Troy School District

**RFP #2425-09 - Addendum #1
BP#2B High School Athletics - Phase #2
January 21st, 2025**

Troy Schools District – RFP #2425-09 BP#2B High School Athletics Renovations - Phase #2

Addendum #1 Bidder Clarifications

6 FLAG POLE FOCAL POINT TURF DETAIL
SCALE 3/8"=1'-0"

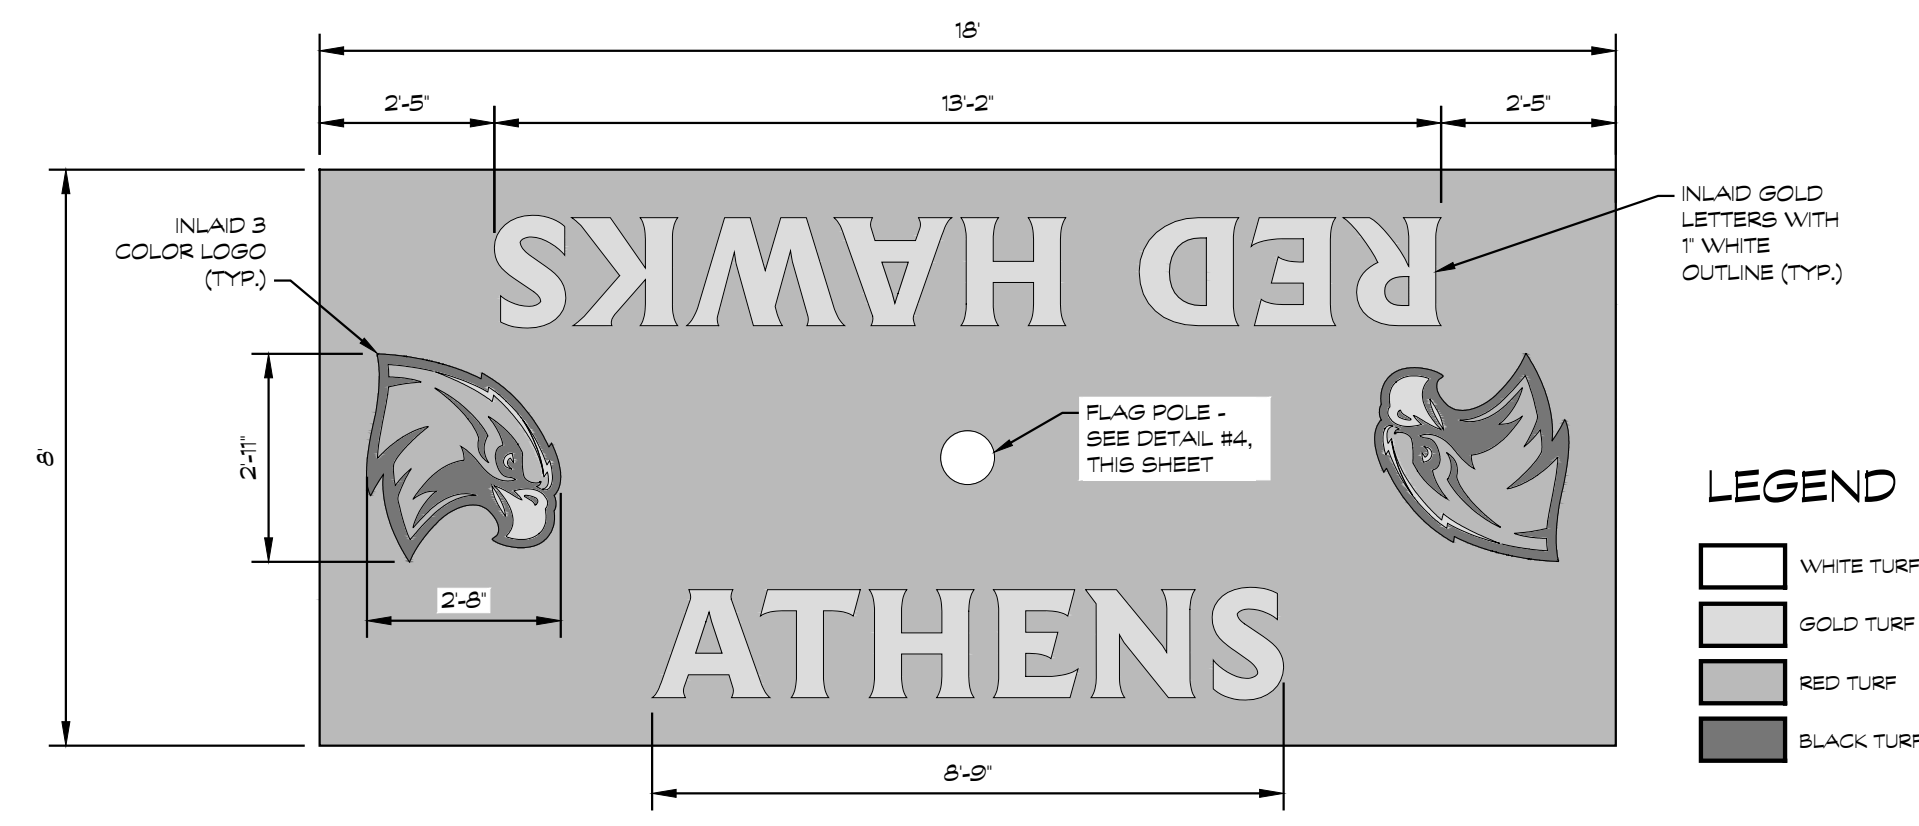
- LD-14 Refer to Drawing No. LD1.12 (reissued):
- A. Revised details; moved JV dugout details to different LD sheet as indicated.
 - B. Revised details; moved scoreboard details and flag pole details from different LD sheet onto sheet as indicated.
 - C. Added synthetic turf graphics detail for flag pole area as indicated.
 - D. Revised name of detail sheet to correspond with the details as indicated.
 - E. Revised flag pole focal point section in its entirety as indicated.

DRAWING NO.
LD1.16

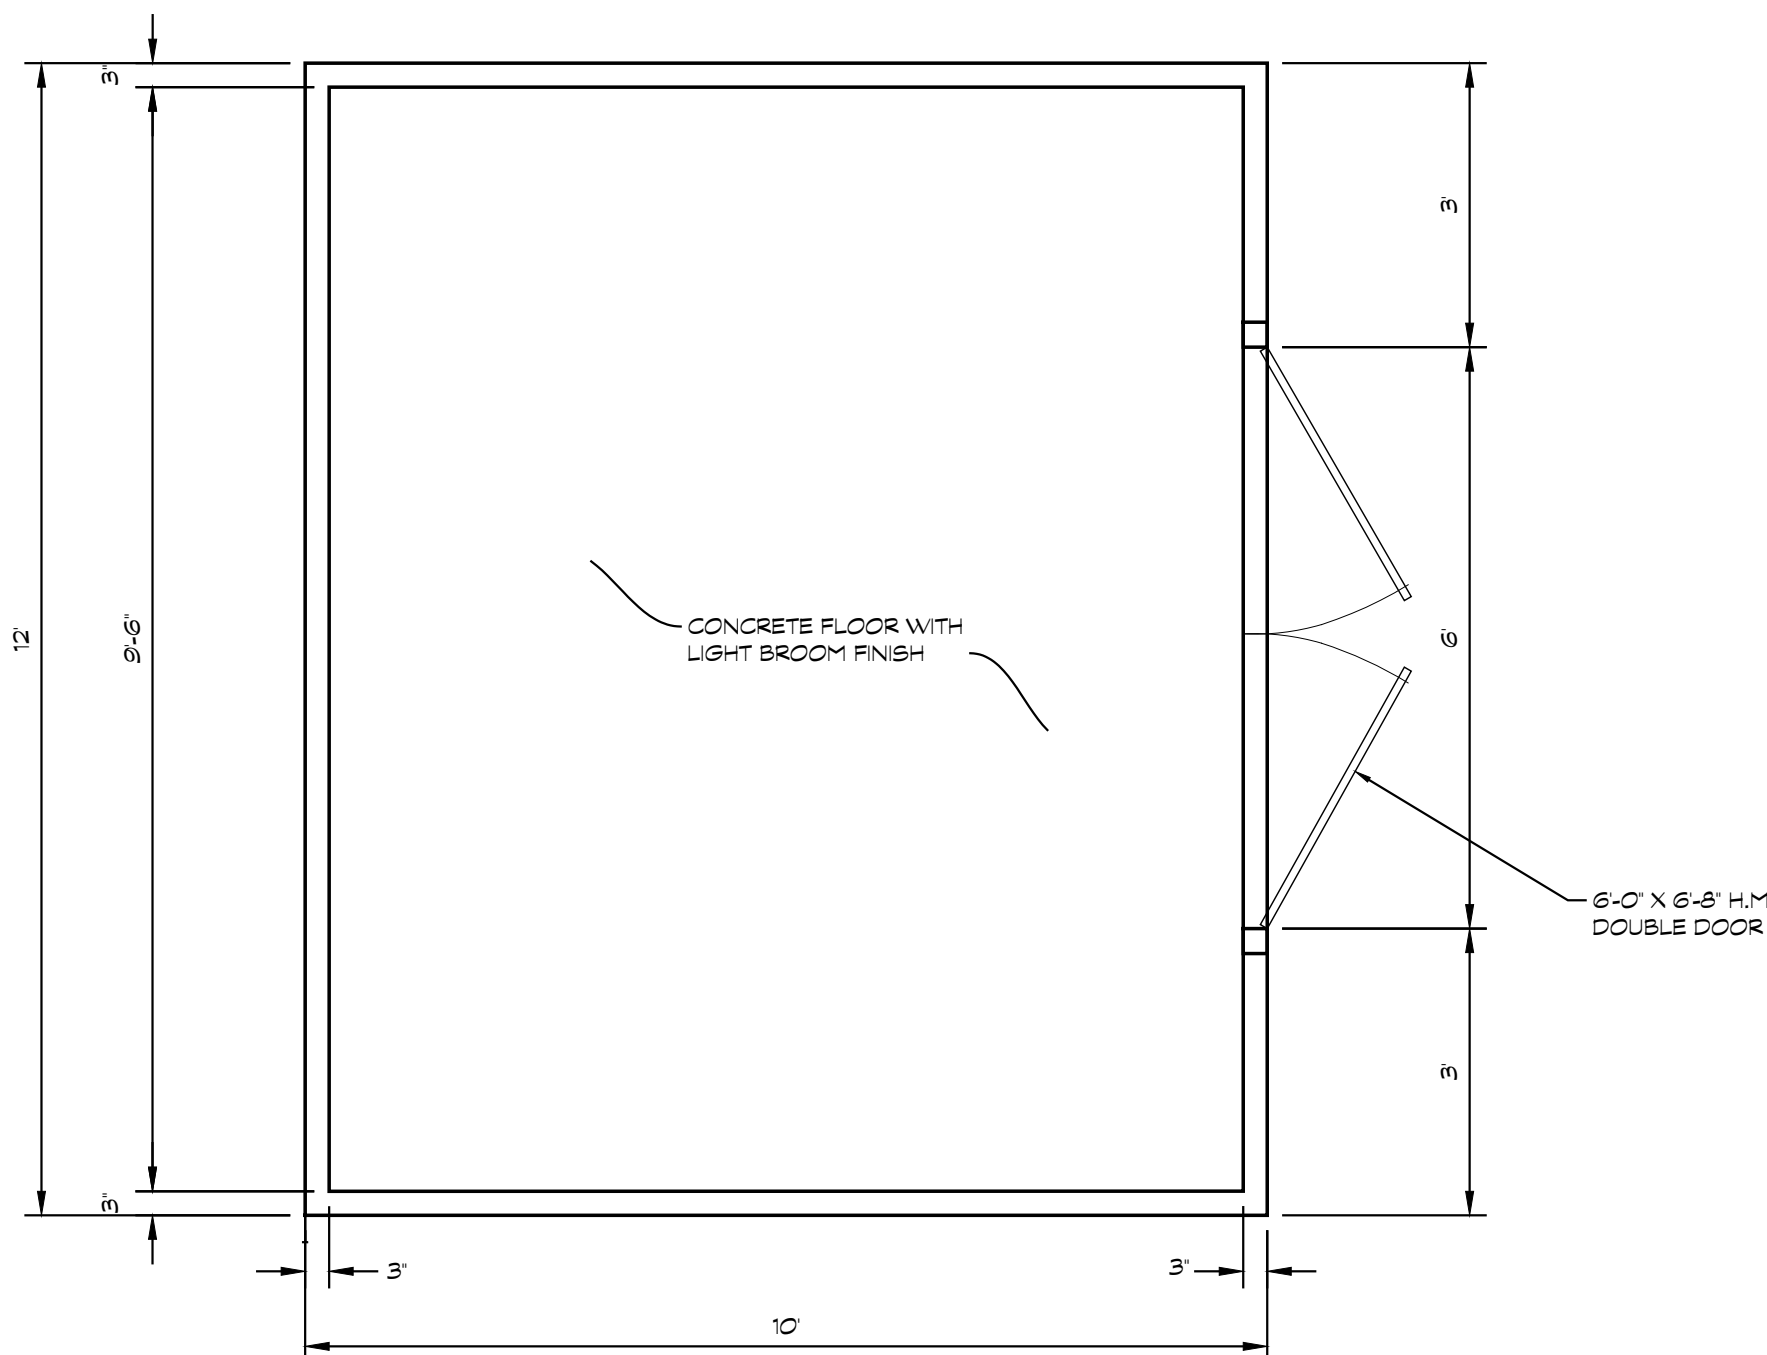
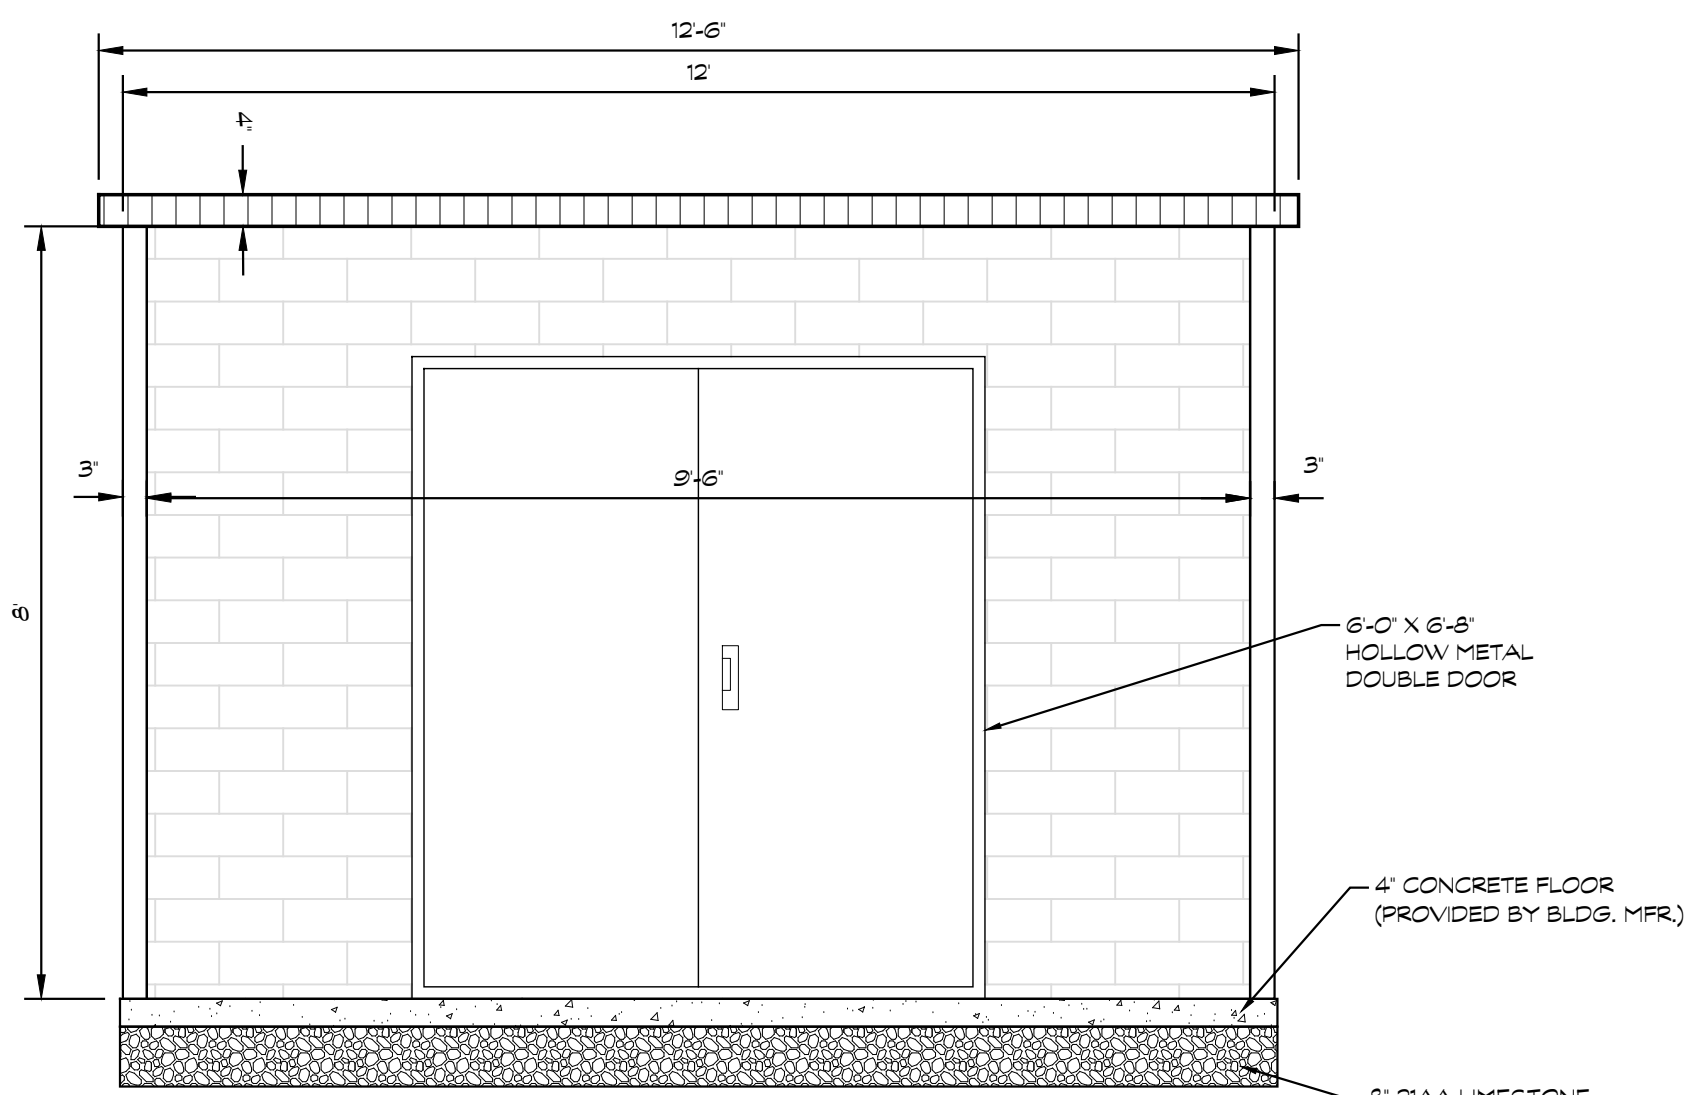
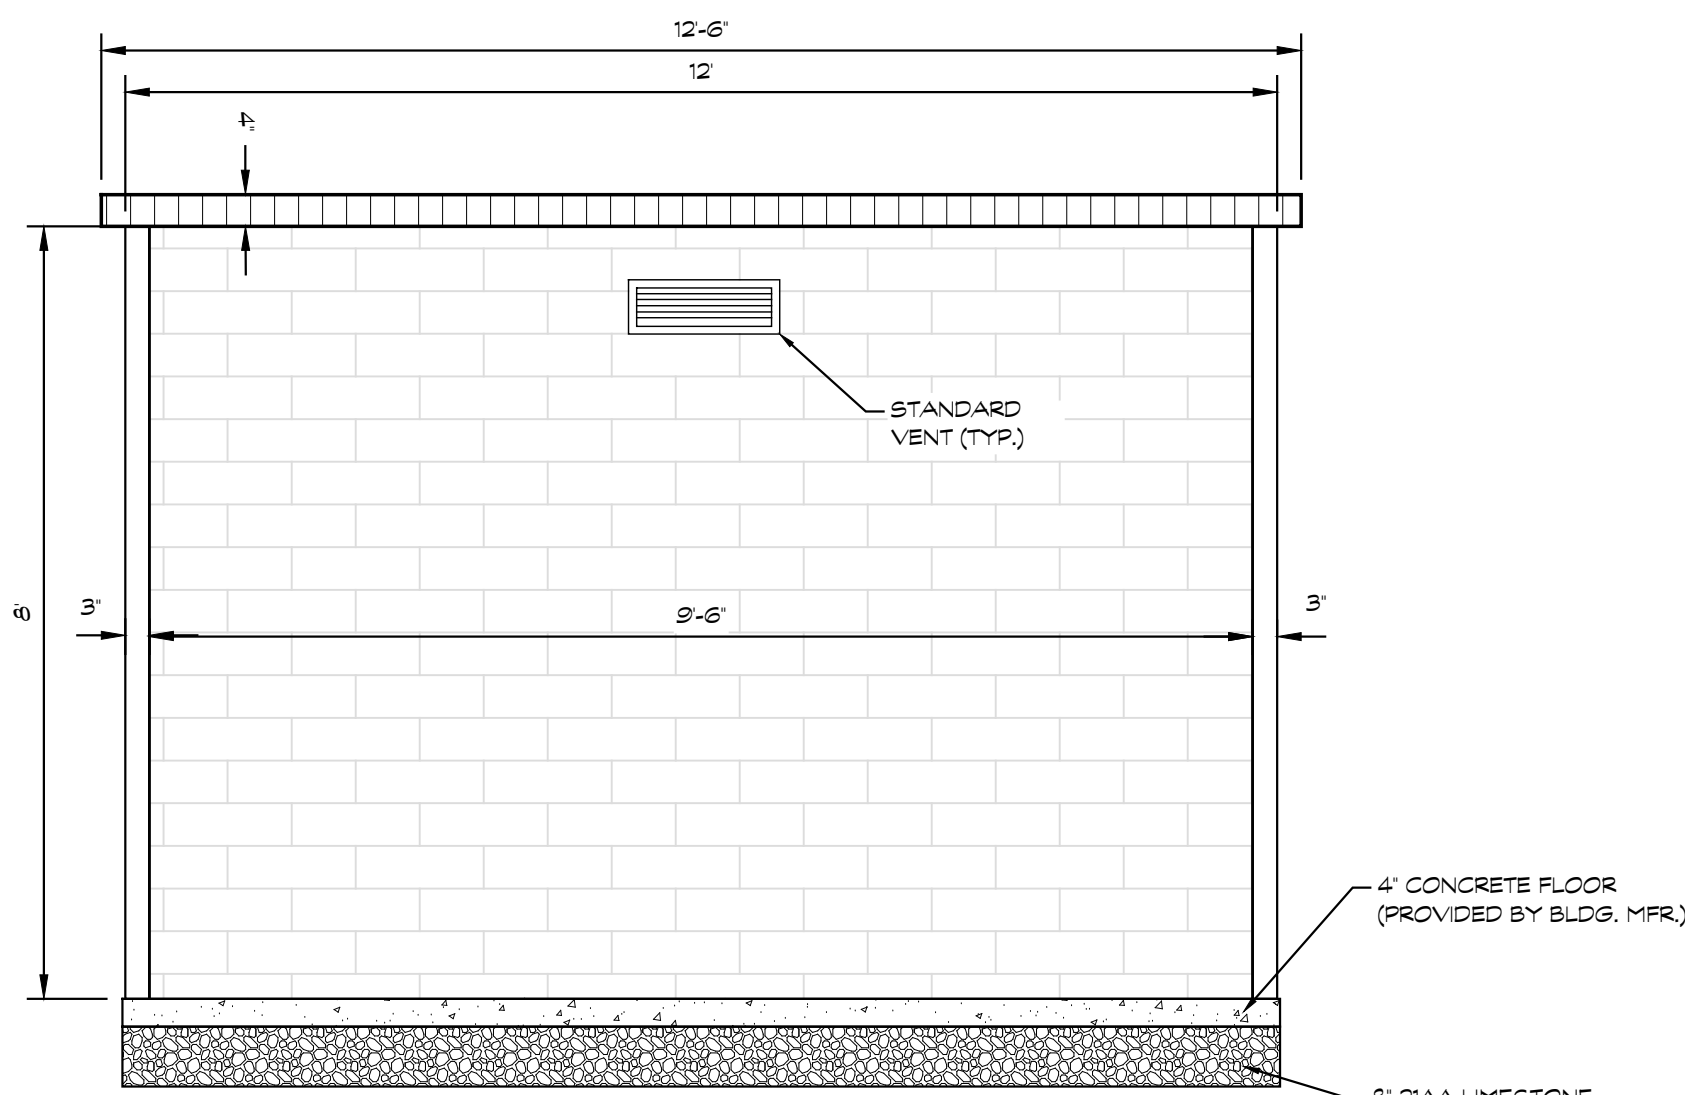
Q: Is there a detail for the precast storage buildings. Do they require a concrete pad?

- LD-15 Refer to Drawing No. LD1.16 (new):
- A. Added drawing sheet for design intent of storage buildings as indicated.

A: Yes, see sheet LD1.16 (Addendum #1). Our detail calls out 4" concrete floor provided by mfr on top of 8" 21AA Limestone compacted base.
